URBAN DESIGN COMMITTEE STAFF REPORT

APPLICATION NUMBER	Urban Design Record #24052
APPLICATION TYPE	Advisory Review and Final Action
ADDRESS/LOCATION	NW Corner 26 th and U Streets
HEARING DATE	April 02, 2024
ADDITIONAL MEETINGS	--
APPLICANT	Aaron Burd, amburd76@gmail.com
STAFF CONTACT	Arvind Gopalakrishnan, 402-441-6361, agopalakrishnan@lincoln.ne.gov

The applicant is proposing to construct two two-story buildings, each with four townhome units, on the vacant lots 2537 and 707 (Hawley Corners CUP, at the northwest corner of 26th and U Streets). The property is adjacent to the Hawley Local Landmark District. The applicant is requesting TIF assistance, thus the project requires design review.

ATTACHMENT D- ELEVATIONS

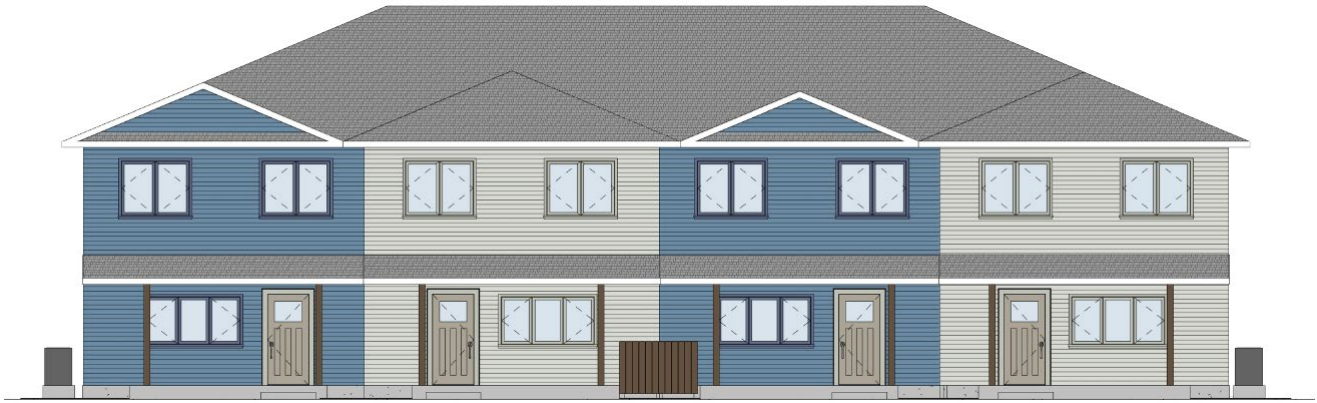
- A member asked if the window casing could be differentiated color-wise, to differentiate it from the siding color. In the design, the trims are the same color as the siding, and the windows would be white.
Currently, most houses in the block and district feature trims either in white or contrasting colors with the siding. Staff suggests standardizing all trims to white, or contrasting colors. This adjustment will enhance depth in the facade and make the siding colors stand out more effectively.

- A member stated that even though 8-inch siding is more available he would like to see it narrower, and the applicant stated it's more cost-effective to have the 8-inch siding.

- A member stated the typical side elevations have major view potential, especially on 26th Street and those look bleak. Worth stated to get better window patterns on those facades as well. Otherwise, they are relatively blank and don't contribute much to the neighborhood.
The applicant stated one side is the garage and they cannot have windows due to LES guidelines since they are next to transformers. They had designed more windows originally but had to remove them.

Worth stated the typical side elevations have major view potential, especially on 26th Street and those look pretty bleak. Worth stated to get better window patterns on those facades as well. Otherwise, they are relatively blank and don't contribute much to the neighborhood

Burd stated one side is the garage and they can't have windows due to LES guidelines since they are next to transformers. They had designed more windows originally but had to remove them.

ATTACHMENT G- PERSPECTIVE IMAGES

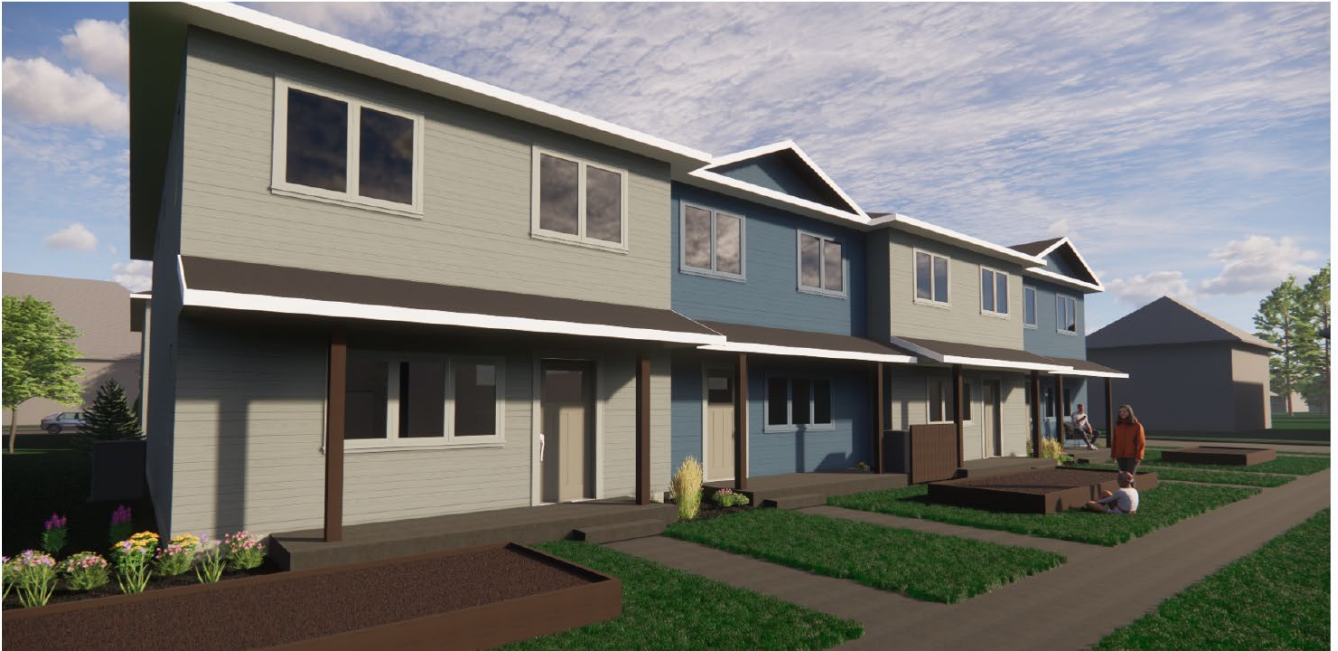
- It would be good if it could look less new and a bit more integrated into the neighborhood. Internal grills would be nice, and though it may not be necessary or code because of the short elevation of grade, would be to still have some railings up front on the porches.

- Members like to see housing going in but would like to see more dimension on the exterior façade. It would be good to do a one-over-one double-hung window or add dimension to the window or main elevations such as a porch rail to match the neighborhood. The style of railing isn't as critical as the presence of a railing. It helps to break up the flatness and neutralness of the façade and gives a nod to architectural styles in the neighborhood.
However, the porch is 5' wide and adding a railing would considerably reduce the usable space. It can be used as a stoop without railing. In staff's opinion, the plants around the porch will add to the aesthetic and hence, might not require railings.

McCown stated he would like it to look less new and a bit more integrated into the neighborhood. Internal grills would be nice, and though it may not be necessary or code because of the short elevation of grade, would be to still have some railings up front on the porches.

Gengler stated she likes to see housing going in but wants to see more dimension on the exterior façade. It would be good to do a one-over-one or add dimension to the window or main elevations such as a porch rail to match the neighborhood. The style of railing isn't as critical as the presence of a railing. It helps to break up the flatness and neutralness of the façade and gives a nod to architectural styles in the neighborhood.
